Accessibility Audit Report

**Middlewich Primary School
Park Road
Middlewich
CW10 9BS**

Date: 5th February 2014

Asset Management Services
Delamere House
Delamere Street,
Crewe
CW1 2JZ

Main School Accessible WC

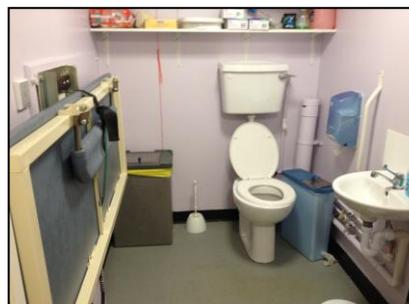
The position of fittings is not to current best practice design guidance and should be upgraded accordingly, including the repositioning of paper towel / soap dispensers and lever flush handles to within easy reach.

The provision of support grabrails is sufficient within the main school toilet cubicle. The Foundation Stage toilet facility has only one grabrail installed. It is recommended that additional grabrails be introduced to meet best practice design guidance.

There is no visual contrast between sanitary fittings, grabrails and the background walls within the main school cubicle. It is recommended that the cubicle wall be re-painted to a darker tone for the benefit of those with a visual impairment.

Emergency call units are installed within each cubicle, however the pull cords to each unit should be adjusted / replaced to ensure that they hang freely with two pull points available.
